## PGM Tester Software SN211: Capabilities and Limitations

**HONDA ServiceNews**

## Installation Instruction Fix: Security System, '02 CR-V

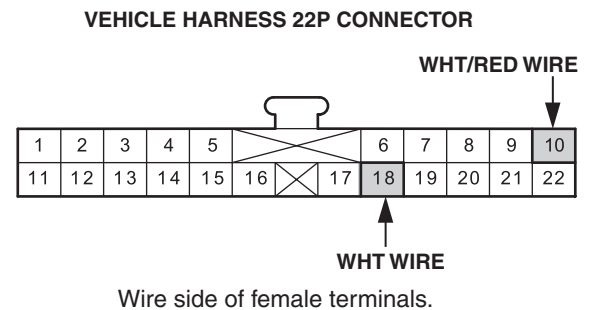
If you've used AII 23086, *Security System*, to install the accessory security system in an '02 CR-V, you might have noticed the illustration in step 16 for the vehicle harness 22P connector is a little tough to follow. The actual connector has more cavities than what's shown in the illustration, so it's hard to tell just where to insert the WHT and WHT/RED wires. Here's a connector diagram that will make it clear:

The WHT/RED wire goes to the security unit, and it is hot at all times. The WHT wire goes to the security system LED. If these wires are inserted in the wrong cavities, the LED or possibly the entire security system may not work.
